Access Compliance Report

Public Rights-of-Way

(Curb Ramps)

Intersection ID: 3947	Main Street: COPPERPLATE_RD	Cross Street: FOUNTAINGROVE_DR	Location: S
ADA ID: F88E61193959	Ramp Type: Perp	Initial Pass/Fail: Fail	Overall Compliance: No
Severity Score: 16.25			
Codes/Mitigation Info/Possible Solution		Field Measurements/Component Compliance

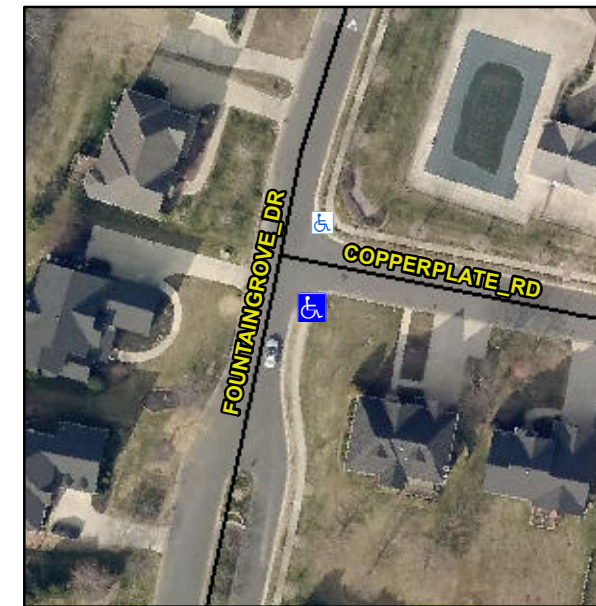
R304.5.3, R302.7

Compliance	Description	Data	Compliance	Description	Data
N/A	Ramp Length (in)	46.0	Yes	Ramp Slope (%)	7.1
Yes	Ramp Width (in)	48.0	No	Ramp XSlope (%)	3.3
N/A	Flare Type LT	N/A	N/A	Flare Type RT	N/A
N/A	Flare Slope LT (%)	N/A	N/A	Flare Slope RT (%)	N/A
N/A	Flare Traversable LT?	N/A	N/A	Flare Traversable RT?	N/A
N/A	Landing Length (in)	N/A	N/A	DWS Provided?	N/A
N/A	Landing Width (in)	N/A	N/A	DWS Contrast?	N/A
N/A	Landing Slope (%)	N/A	N/A	DWS Length (in)	N/A
N/A	Landing X Slope (%)	N/A	N/A	DWS Full Width?	N/A
N/A	Landing Curb? (Y/N)	N/A	N/A	DWS Offset (in)	N/A
N/A	Shared Landing?	N/A			
N/A	Gutter Ponding?	N/A	N/A	Gutter Slope (%)	N/A
N/A	Gutter Lip Ht (in)	N/A	N/A	Gutter X Slope (%)	N/A
N/A	Painted X Walk1?	No	N/A	Painted X Walk2?	N/A
	X Walk 1 Direction	To N		X Walk 2 Direction	N/A
N/A	X Walk 1 Width (in)	N/A	N/A	X Walk 2 Width (in)	N/A
	X Walk 1 Slope (%)	3.1		X Walk 2 Slope (%)	N/A
	X Walk 1 X Slope (%)	3.2		X Walk 2 X Slope (%)	N/A

N/A	Ramp inside XWalk1?	N/A	N/A	Ramp inside XWalk2?	N/A
	Road Slope (%)	N/A	N/A	Clear Space?	N/A
	Road X Slope (%)	N/A	N/A	Clear Space to XWalk (in)	N/A
N/A	Any Obstructions?	N/A	N/A	Storm Grate/Utility Hazard?	N/A
	Obstruction Type			Storm Grate/Utility Type	
		N/A			N/A
		No		Surface Condition? (G/P)	Poor

Remove & Replace Entire Ramp.
